BID ADDENDUM NO. 2

OWNER: EDGEMONT UNION FREE SCHOOL DISTRICT

PROJECT NAME: HIGH SCHOOL BUILDING 'A'
INTERIOR RENOVATIONS

DATE: October 28, 2025

DRAWING NO.
AR100

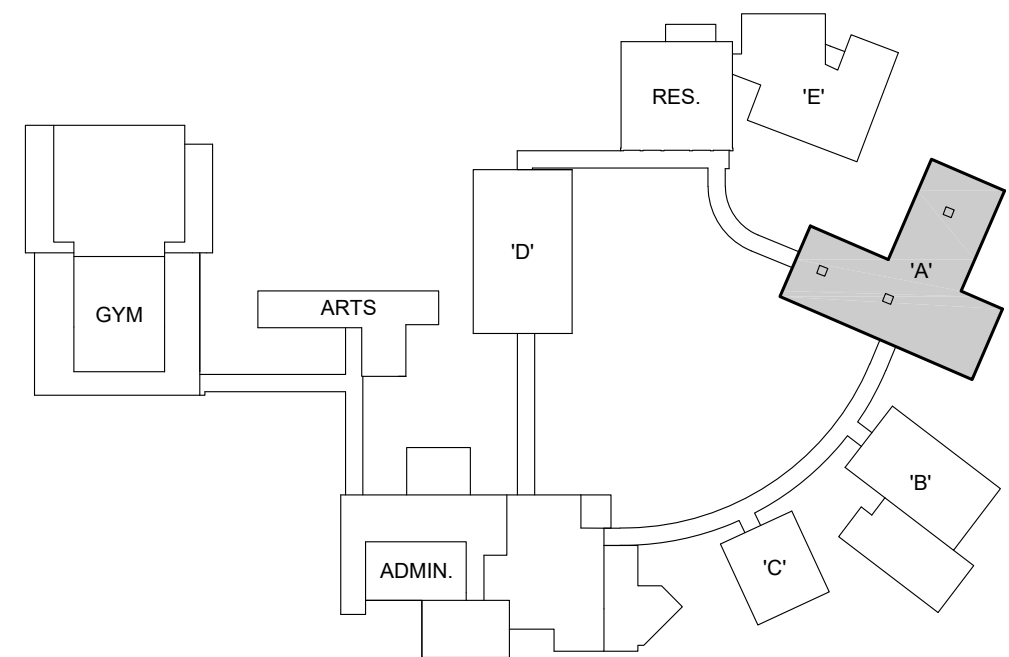
DRAWING AR100 – FIRST FLOOR REMOVAL PLAN

DELETE Note R19

REMOVE CMU locker end walls.

ADD Removal Note R44 "Saw-cut and remove CMU locker end wall from slab to structure above. Patch disturbed surfaces to match existing adjacent surfaces. Grind down any high spots under existing wall for installation of new CMU end walls."

DRAWING NO.
A101

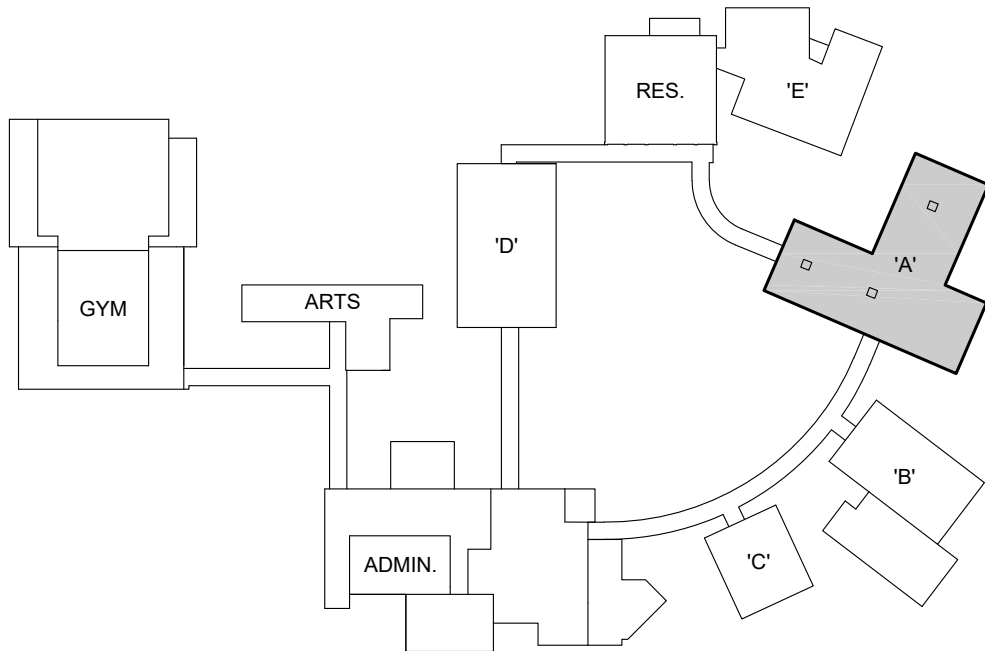
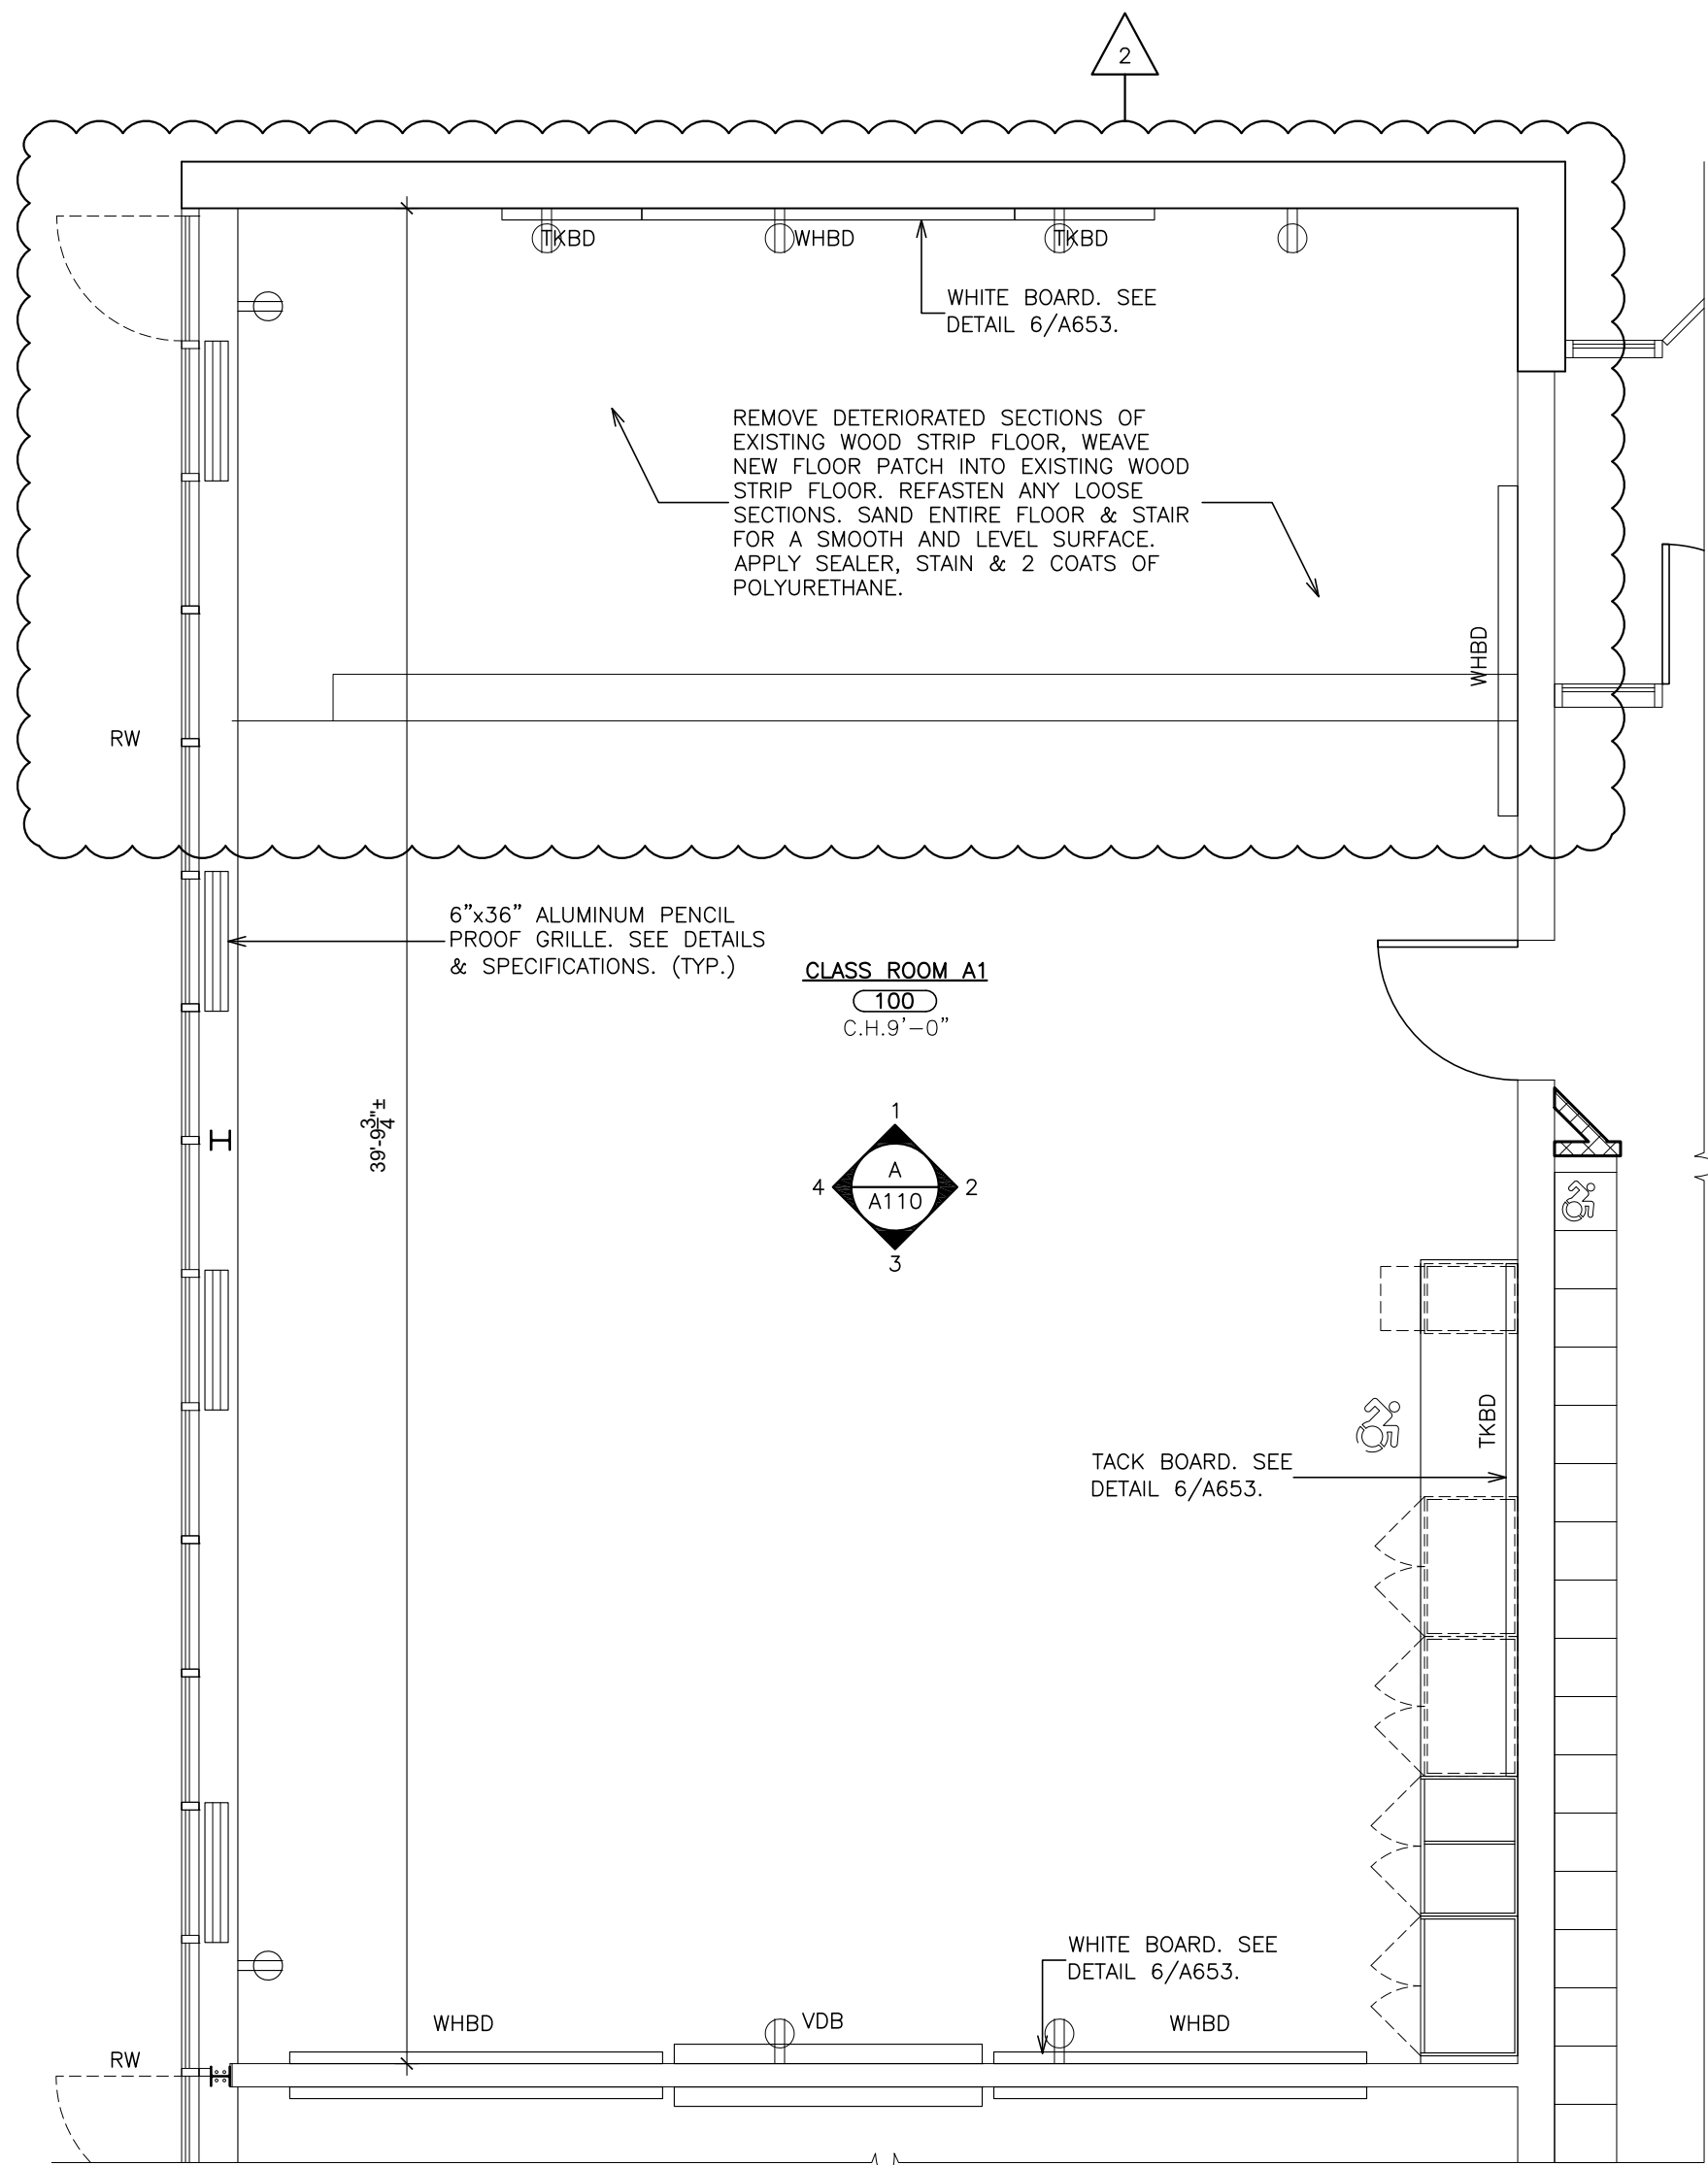
DRAWING A101 – FIRST FLOOR PLAN

ADD CMU locker end walls as per Sketch SK-A1.0 attached to this addendum.

ADD laminated gypsum board wall covering in rooms 100, 101, 102, 103, 104, 119, 120, 121, 122, 123, & 124 as per Sketch SK-A1.2 attached to this addendum.
